35/13-06DD 23 IRVING ST

HISTORIC PRESERVATION COMMISSION STAFF REPORT

Address:	23 Irving St, Chevy Chase	Meeting Date:	10/25/2006
Resource:	Contributing Resource Chevy Chase Village Historic District	Report Date:	10/18/2006
Applicant:	Duane & Paula Gibson (Paul Locher, Agent)	Public Notice:	10/11/2006
Review:	HAWP	Tax Credit:	N/A
Case Number:	35/13-06 EE DD	Staff:	Michele Oaks
PROPOSAL:	Additions

RECOMMENDATION: Approve with Conditions

GIBSON RESIDENCE
PROPOSED SITE PLAN

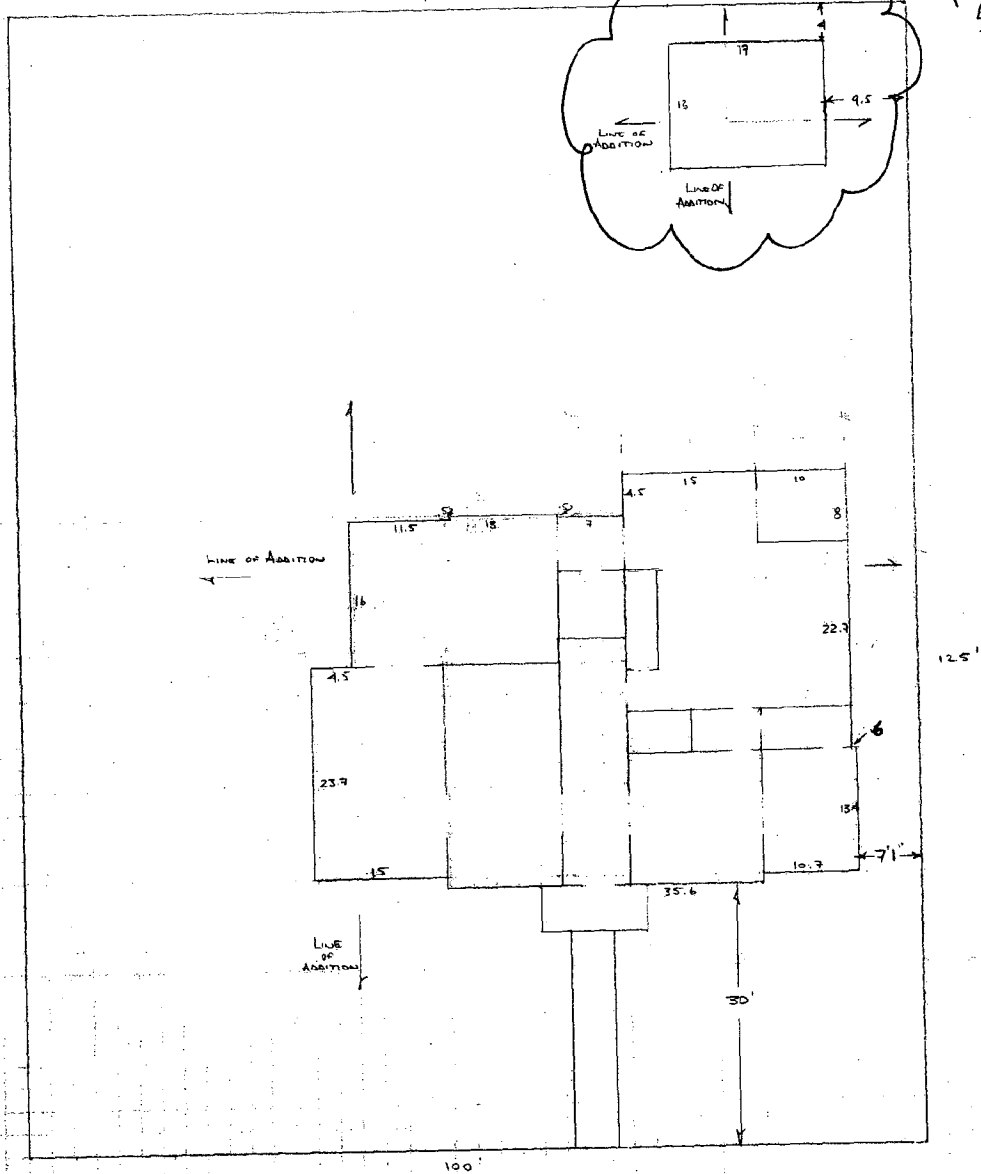
These alterations are also completely contained at the rear of the house and will not be visible from the public right-of-way. The designer has minimized the need to significantly increase the size of the overall footprint by re-working existing additions, demolishing non-contributing additions and constructing two-story additions in their place and extending existing ells. Thus, maintaining a significant amount of the open-space on the lot, which helps to achieve the goal of preserving the Village's park-like character (see site plans on circles 18-19). Staff recommends approval.

Topic #10 Remove two (2) trees for the proposed, new construction.

As the tree survey provided indicates, only two trees would be impacted as part of this construction. The applicants are requesting removal of these trees. As the attached June 2005 Tree Assessment Report indicates (circles 13-16), the proposed 24" White Oak tree to be removed is in moderate decline. The Commission has made it a policy to add a condition to HAWP approvals requiring that applicants receive approval from the Chevy Chase Village Arborist for the removal of trees and the tree protection plan for the site. The applicants have been granted permission by the Chevy Chase Village Managers to remove the subject trees. Staff recommends approval.

EXISTING EAST ELEVATION

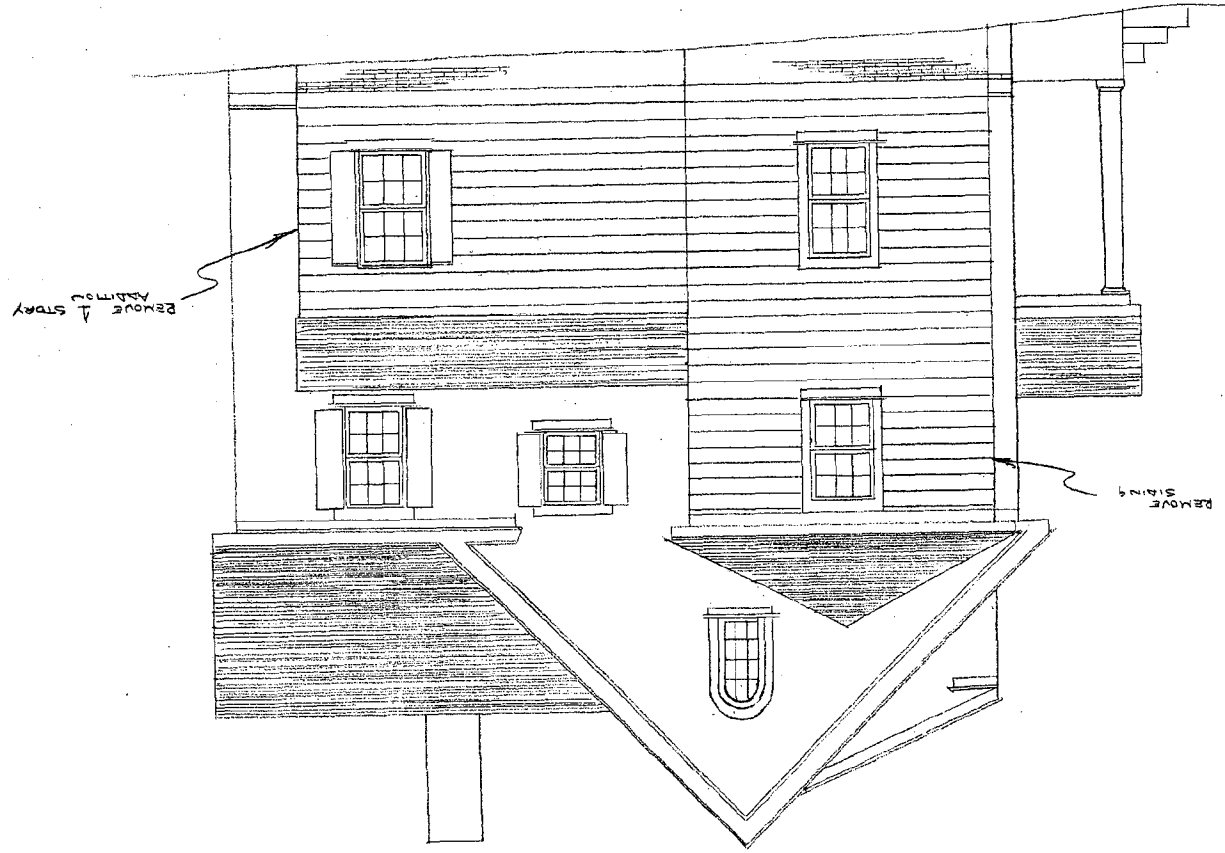
8. The applicant is approved for the currently submitted drawings based on the above conditions, however, if approved through the Chevy Chase Village variance process, a matching overhang on the east façade is preferred.

1. Remove the existing windows on the front elevation of the existing two-story, addition, which protrudes from the east elevation and replace them with a paired, 6/6 double hung window on the first floor and a 6/6 double-hung, window flanked by louvered shutters on the second (circles 20-21). Relocate the existing window on the second floor of the addition's east elevation (circles 22-23).

2. Remove all of the non-original aluminum siding from the two-story addition and replace it with stucco to match the main massing.
3. Demolish the existing one-story, non-contributing, shed roof addition, which protrudes from the rear section of the east elevation of the house (circle 22).

Topics #1 & #2: Remove the existing windows on the front elevation of the existing two-story, addition, which protrudes from the east elevation and replace them with a paired, 6/6 double hung window on the first floor and a 6/6 double-hung, window flanked by louvered shutters on the second. Relocate the existing window on the second floor of the addition's east elevation. Remove all of the non-original aluminum siding from the two-story addition and replace it with stucco to match the main massing.

The existing two-story, addition has had several modifications and alterations. The original one-story addition, the only contributing element in this addition, has lost most of its integrity, due to these significant alterations. The proposed removal of the siding, the application of stucco and the window modifications and relocations are consistent with the existing architectural style of the house. Staff recommends approval.

EXISTING EAST ELEVATION

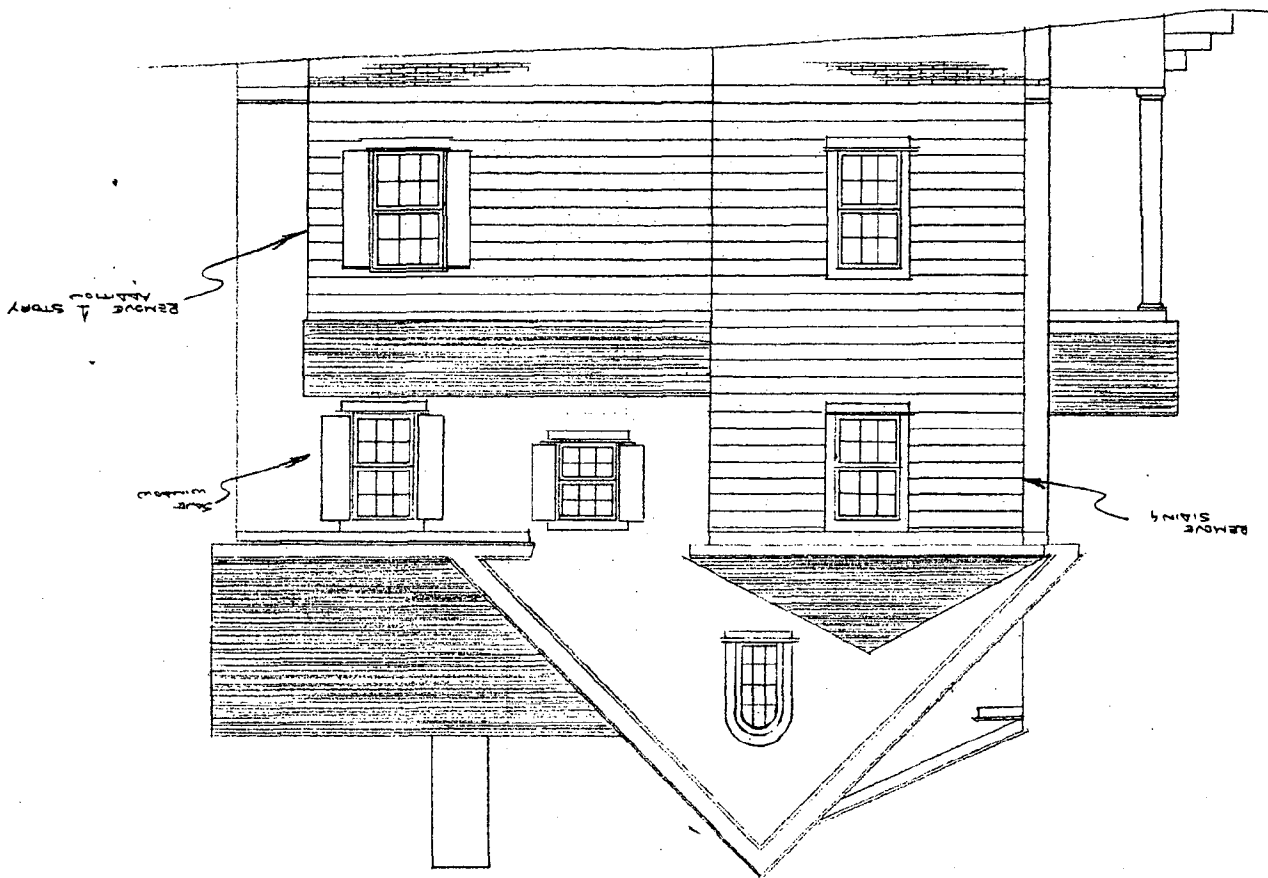
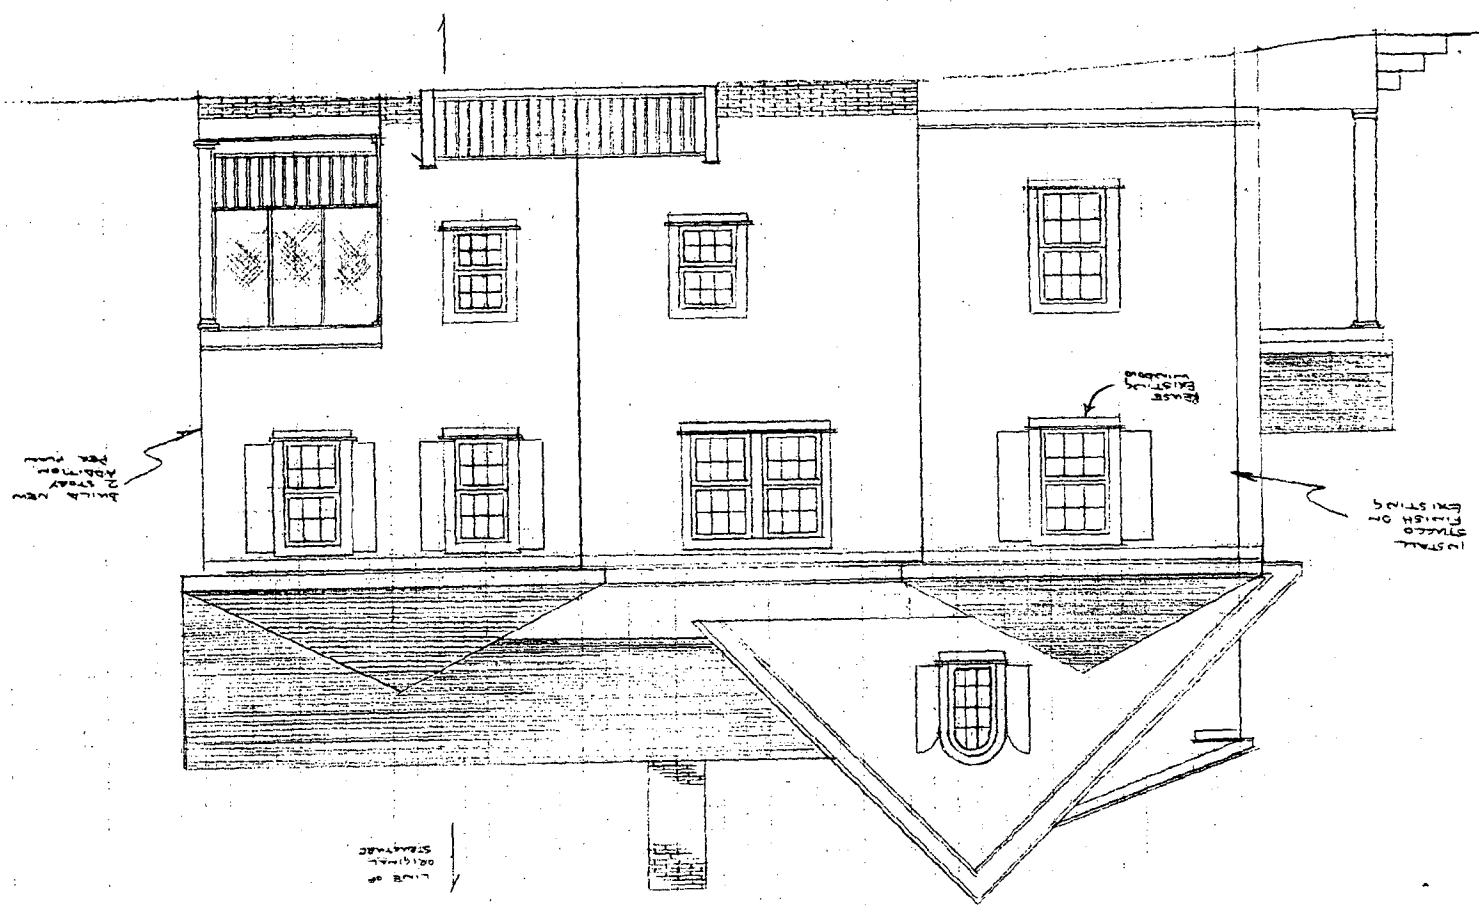
The applicants have addressed the concerns expressed by the Commission at the previous public hearing. The new plan places the addition behind the original massing on the east elevation with an 18” offset. The long wall is broken up at the point where the rooflines change with a second offset of 6”. The window has been re-centered on the second floor of the original massing on this façade as well.

REMOVE EXISTING FINISHES

REMOVE EXISTING FINISHES

INSTALL STUCCO FINISH ON EXISTING STUDS

Roof Layout Plan
Main Roof

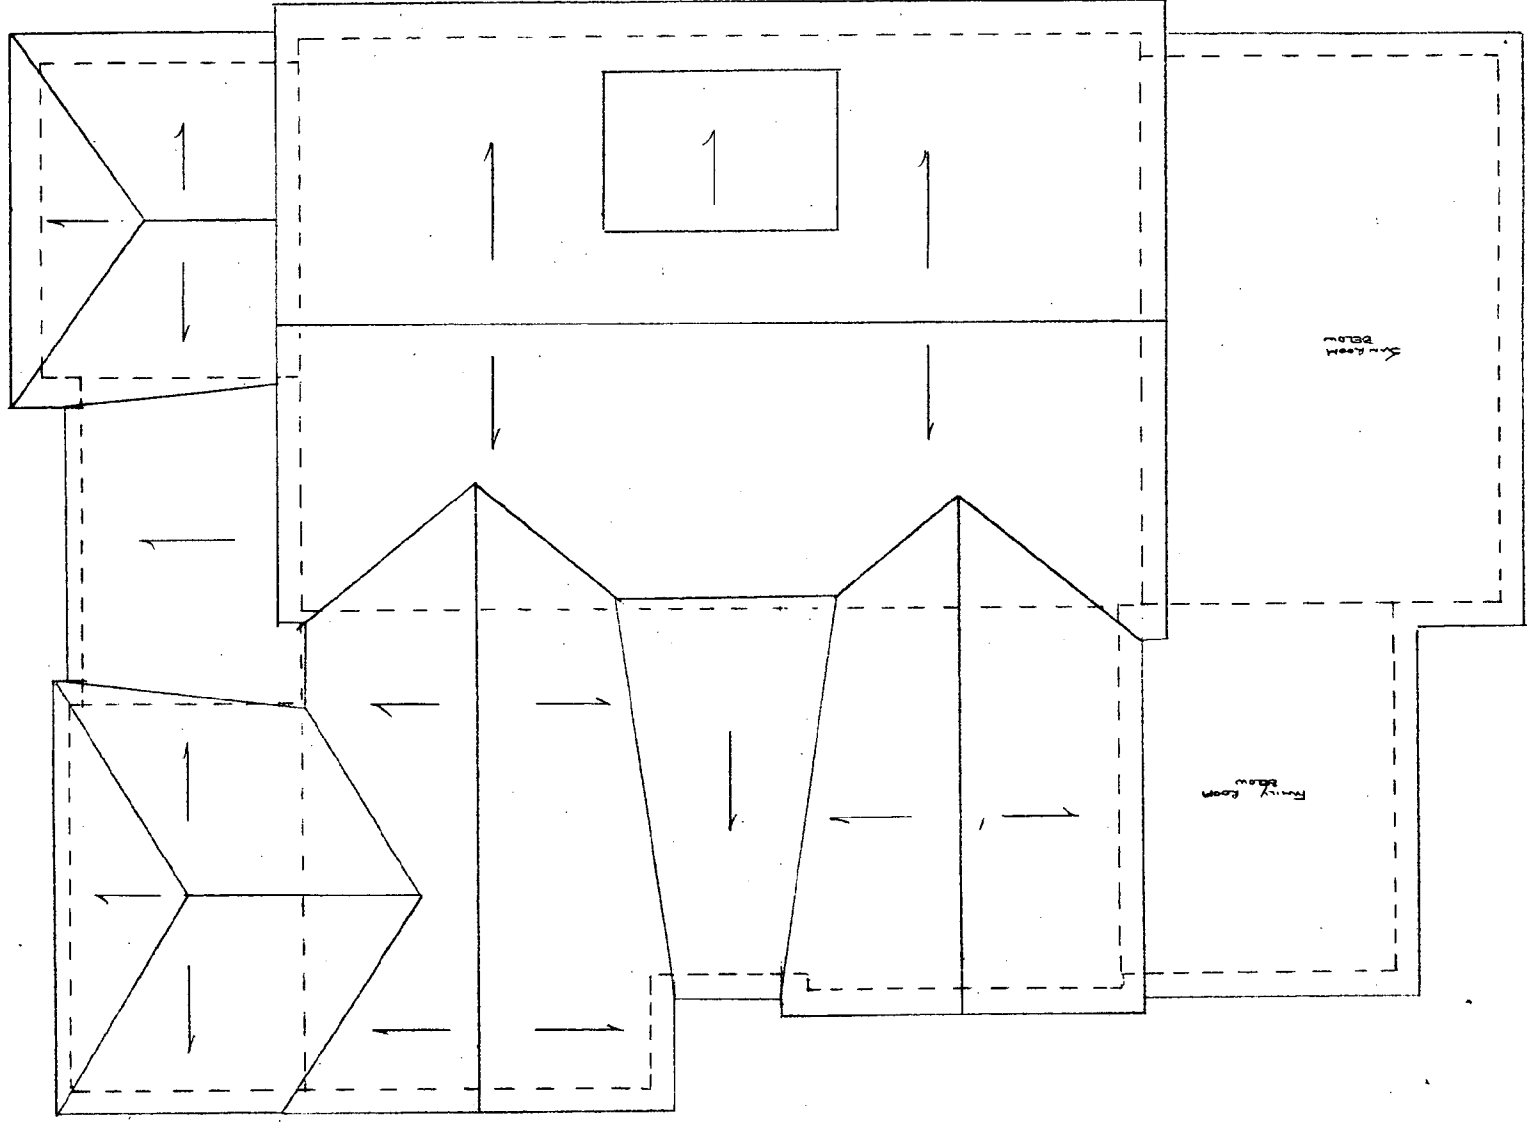
The Commission reviewed this HAWP application at their October 25, 2006 public hearing (transcript is attached beginning on circle 30). The Commission was generally supportive of the project, however, asked the applicant and their designer to study alternative solutions to break up the massing on the east elevation. Additionally, the Commission asked for a roof plan and a more detailed site plan.

The agent has also provides a roof plan and a more detailed site plan, with a cross section showing the proposed retaining wall.
